Response to the editor

Anonymous Referee #1

Reviewer #4 (Report #2)

Figure 1: Weather data from the SAFRAN reanalysis at the grid point covering Irstea building for three past snow events.

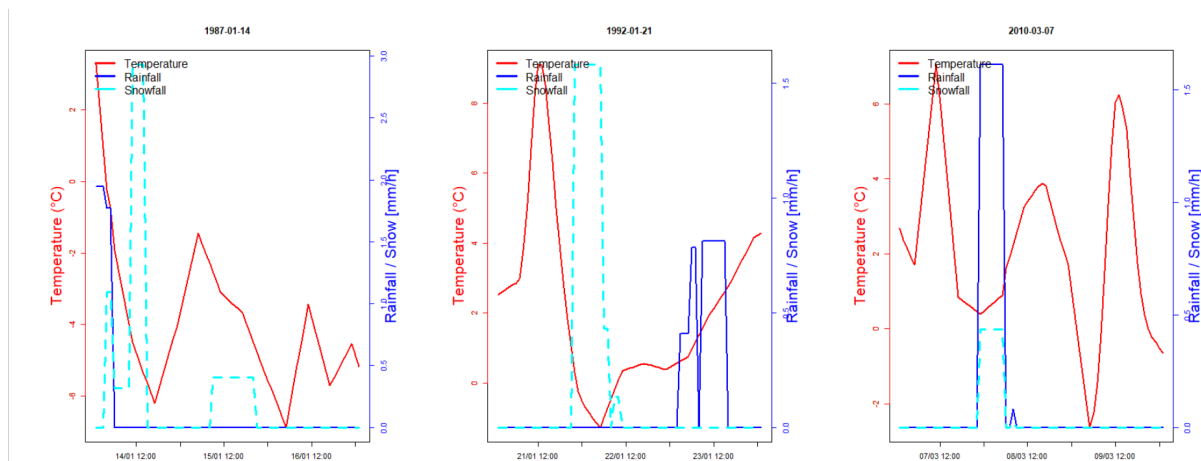
#RC1.20 I.249-250: The 2018 event showed that rain on snow is very important. Has it rained after these snowfalls? how much?

Figure 1 below shows the weather data from the SAFRAN reanalysis at the grid point covering Irstea building for three past snow events. It has not rained after the snowfall on the 14-01-1987 according to SAFRAN data. Some rain has been recorded for the other two events but they are limited to a few mm. For the 7th of March 2010, produce mostly rain instead of snow, which does not correspond to the 10 cm observed on this date. Consequently, we have decided to add only a sentence indicating the amount of rain after the snow for the event of the 22/01/1992.
